**Pacific Gas and
Electric Company®**

PG&E Letter DCL-16-028

Diablo Canyon Units 1 and 2
Docket No. 50-275, OL-DPR-80
Docket No. 50-323, OL-DPR-82
License Amendment Request 16-02
License Amendment Request to Revise Technical Specification 3.4.12, "Low
Temperature Overpressure Protection (LTOP) System"

License Amendment Request to Revise Technical Specification 3.4.12, "Low Temperature Overpressure Protection (LTOP) System"

Table 1 – LTOP Maximum Injection Flows

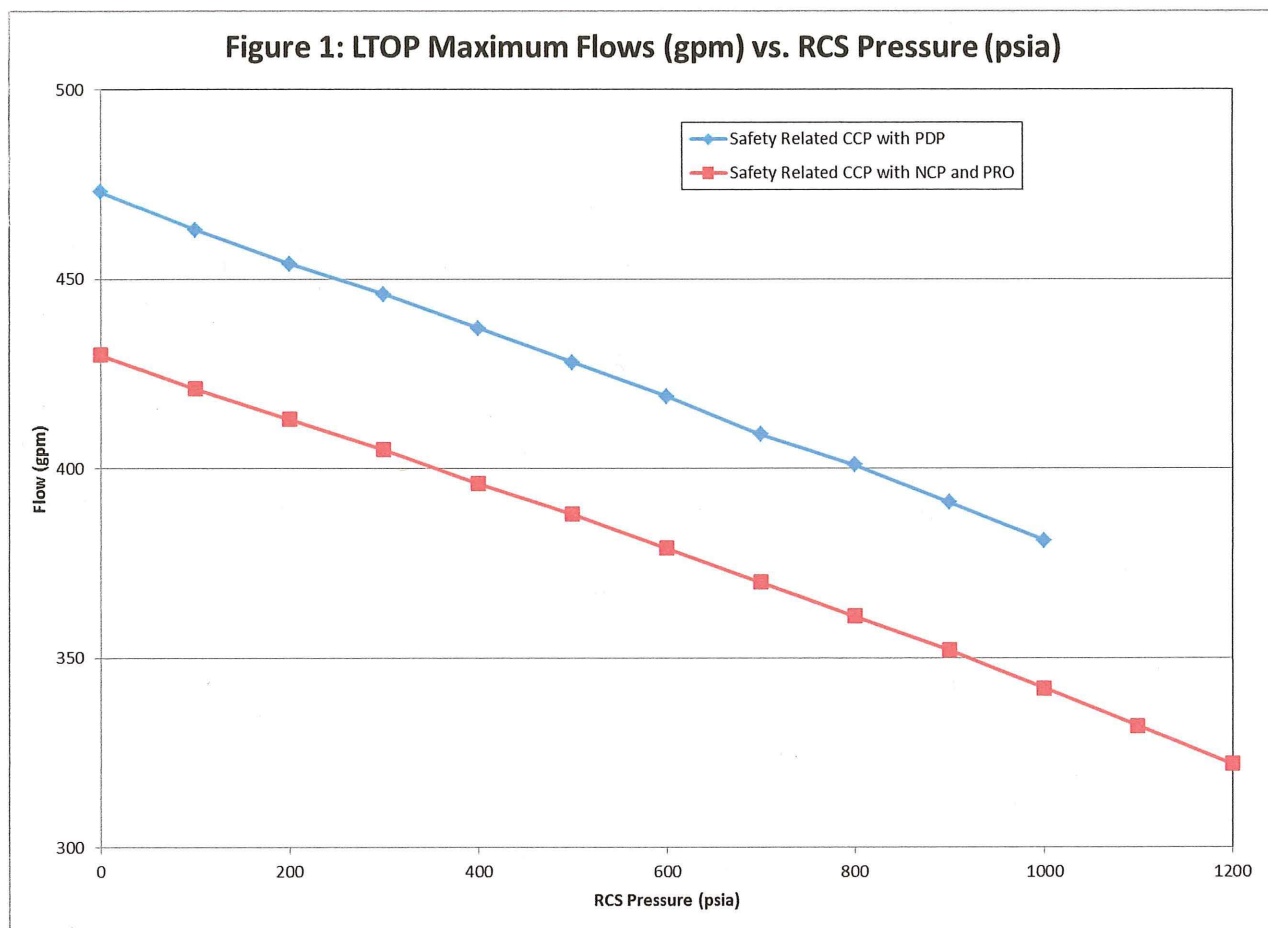
configuration would not result in any additional loss of LTOP margin associated with the existing LTOP PDP mass injection limits. Table 1 also compares the current LTOP analysis assumed mass injection capability for one safety-related CCP with the PDP, with the limiting calculated values for one safety-related CCP and the NCP with the LTOP orifice installed.

As described above, after the installation of each NCP on Unit 1 and Unit 2, test data was obtained and verified to ensure the actual operating performance of the NCP aligned to the LTOP orifice remained bounded by that assumed for the calculated values in Table 1. Figure 1 plots the limiting NCP mass injection capability aligned to the LTOP orifice and shows that the maximum flows are well below the values for the safety-related CCP with the PDP that are already assumed in the LTOP analysis. This confirms that the current LTOP analysis bounds the combined operation of one safety-related CCP and the NCP aligned to the LTOP orifice in support of this LAR.
